**DECLARATION
FOR THE

EXPLANATION OF SIGNIFICANT DIFFERENCES**

The Pownal Tannery Superfund Site is located in the Town of Pownal, Vermont.

Pownal Tannery Superfund Site Pownal, Vermont

Figure 2 Map showing sketch of impacted areas

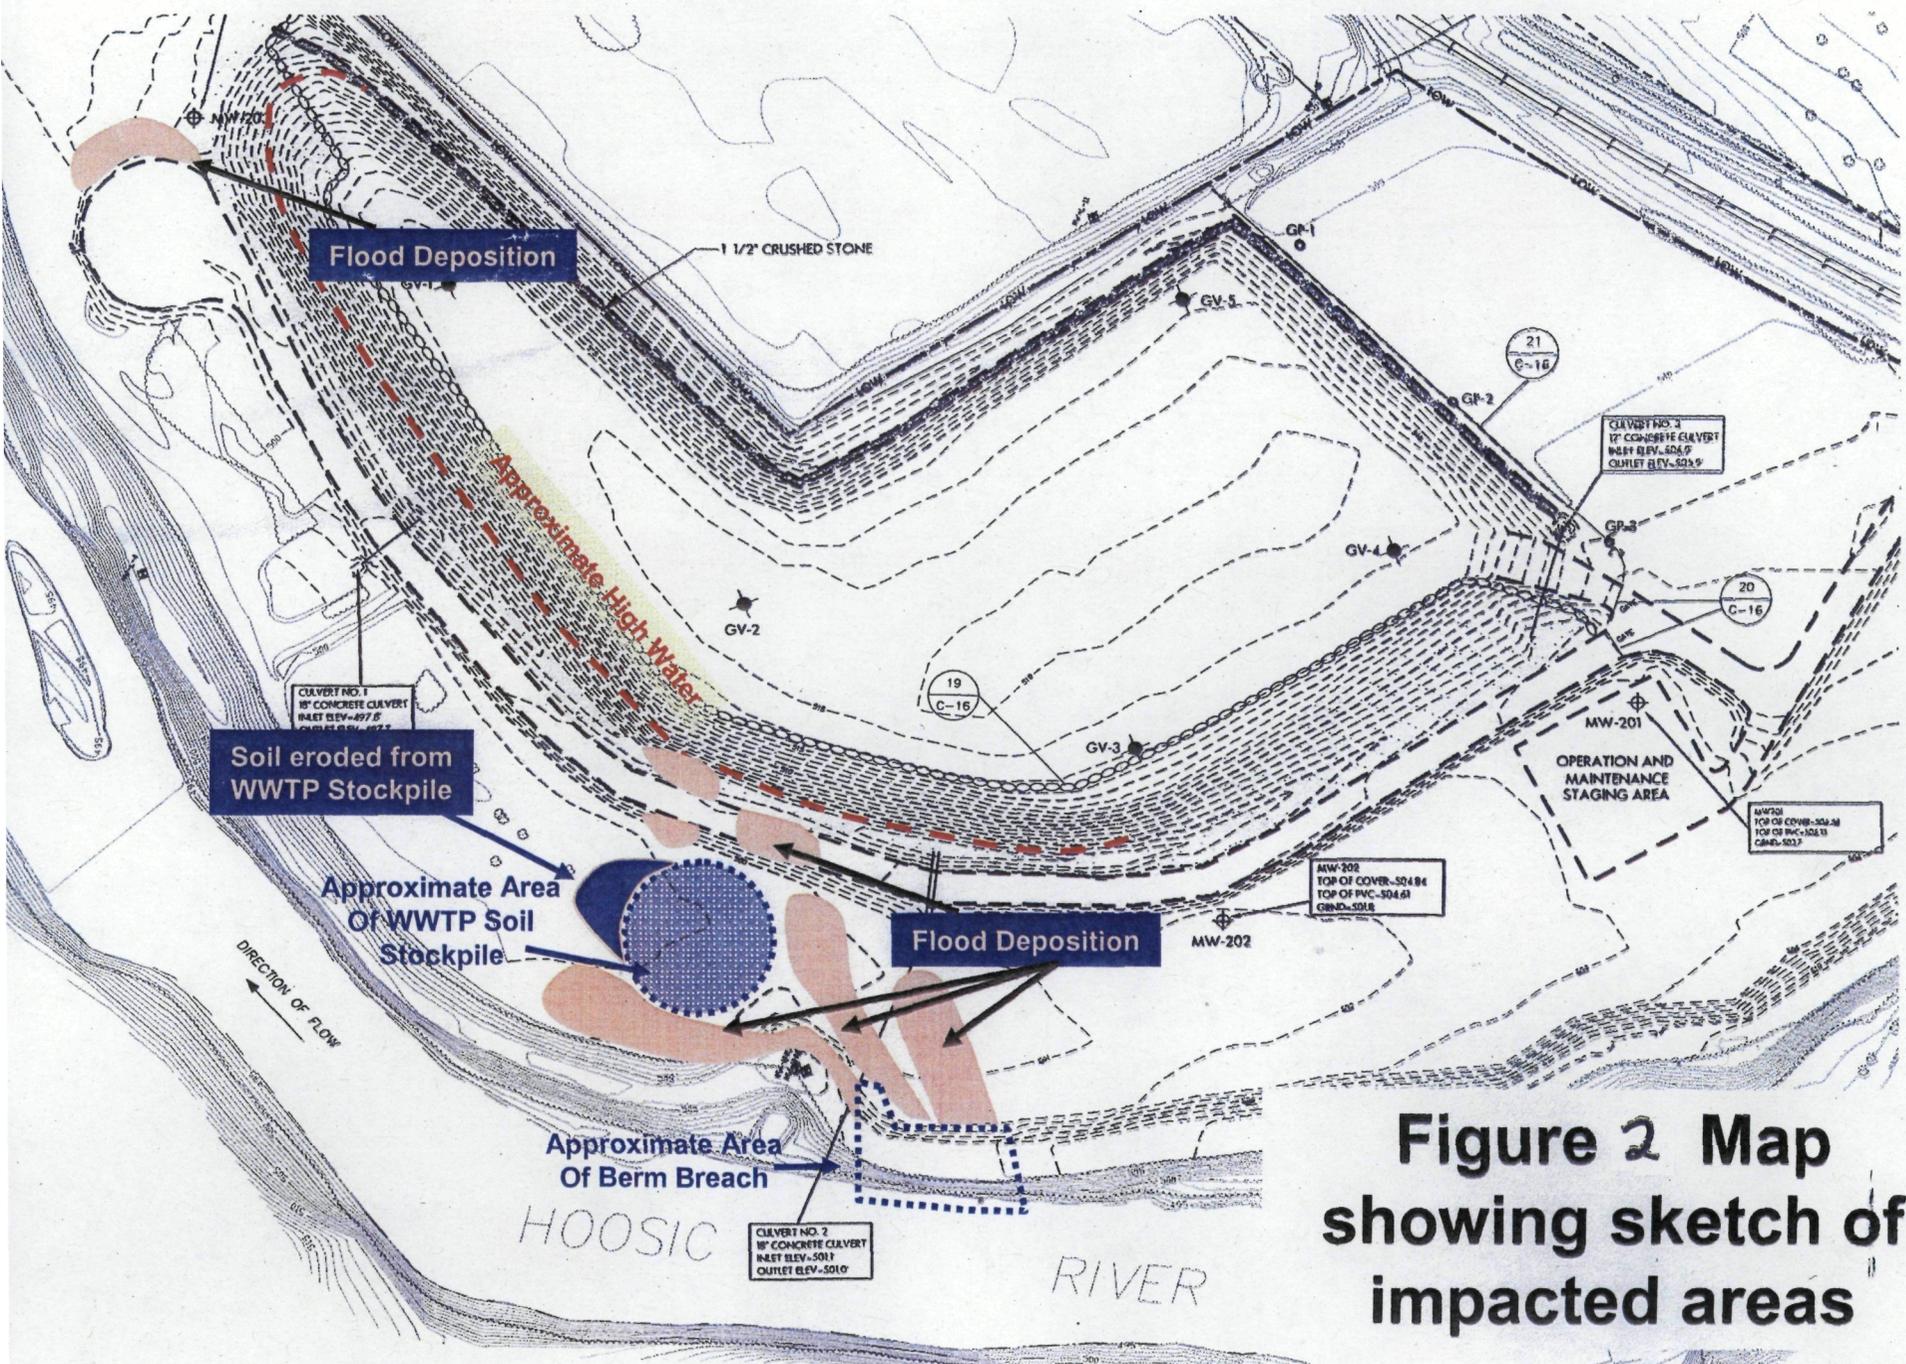
In October of 2005, a significant flood event altered a portion of the former facility's earthen berm that is located between the newly constructed Lagoon Area Landfill and the Hoosic River (Attachment A and Figure 2). While this flooding event did not damage the Landfill, it damaged the surrounding access road to the Landfill. The effects of the berm breach were likely exacerbated by the presence of a large soil stockpile in the engineered flood conveyance area. This stockpile was created without the knowledge of EPA or the VTDEC by the contractor building a town waste water treatment facility on-site. The Town of Pownal removed the stockpile and repaired the access road. It was determined by EPA and the VT DEC that the section of the berm that eroded did not alter the protectiveness of the remedy and should not be repaired. Furthermore, the breaching of the berm did not impair flood storage capacity or the protection of the Lagoon Area Landfill from future storm events (Attachment B). EPA and the VT DEC acknowledged that a portion of the remaining berm, not affected by the

2005 flood, has a small volume of waste under the berm that could not be addressed by the remediation and therefore requires that the limited section of the berm be maintained and that institutional controls be established to limit future disturbance/excavation in that area (e.g., deed restrictions) (Figure 2).

The 2002 ROD required that institutional controls be imposed to 1) prevent the disturbance of the capped soil and sludge in the Lagoon area, and 2) to prevent the ingestion of groundwater from beneath the five existing lagoons. While the ROD did not include a requirement for institutional controls for the other parcels at the Site (that were addressed through the 1999 NTCRA), EPA has determined that institutional controls are necessary at all parcels at the Site where waste has been left in place. This specifically includes, deed restrictions at the Dean Road Landfill and the Lagoon Area Landfill to protect the integrity of the caps and other components of the remedy, groundwater use restrictions, and deed restrictions in portions of the Lagoon Area berm where waste is still present to prevent future disturbance and/or excavation.
